SUBJECT: ACCC – SKYLIGHT/ROOFING REPAIR - DESIGN – ADDENDUM #2

JOB TITLE: ROOF REPLACEMENT & SKYLIGHT
ATLANTIC CITY, NEW JERSEY
OWNER: CASINO REINVESTMENT DEVELOPMENT AUTHORITY

SHEET TITLE: ROOF PLAN

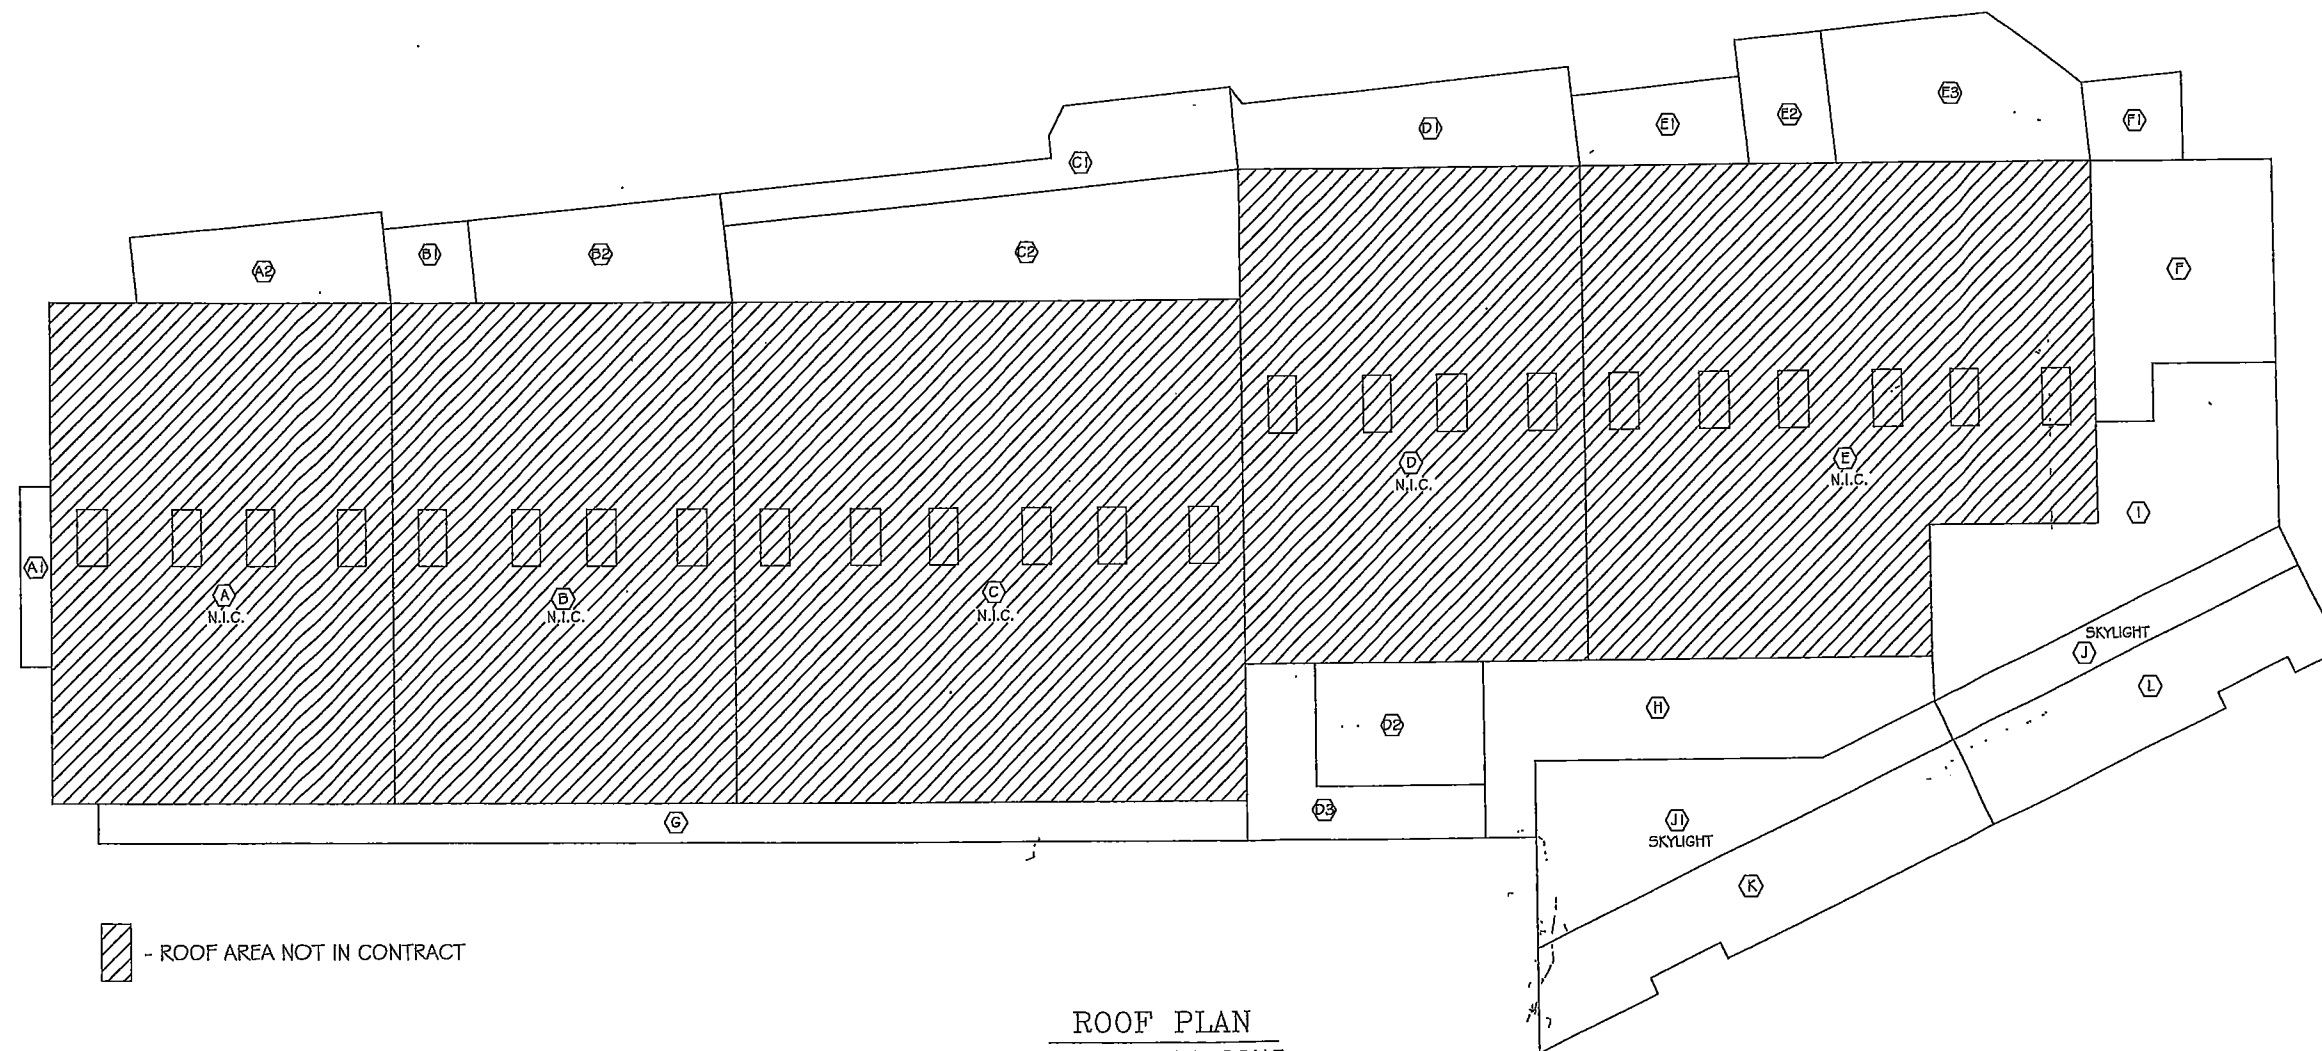
1. Please indicate if the window washer davits on the roof are still in use and should be flashed with the new roofing system, or if they are no longer in use and could be removed and roofed over, eliminating the penetrations and resultant flashings.
Davits to stay but be reflected in the Construction RFP as an alternate for removal.

6. Will the design have to be at Factory Mutual Global Standards
No.
7. Will you want the cost estimate for roof areas D2 and D3 to be combined with the H/I roof area construction cost estimate, or do you prefer it as a stand-alone document?
Provide separate construction estimates for sections; 1) H & I, 2) K & L, 3) JI & J (Skylights) 4) D2 & D3 (including Skylight). Expansion Joints included in all itemized estimates.
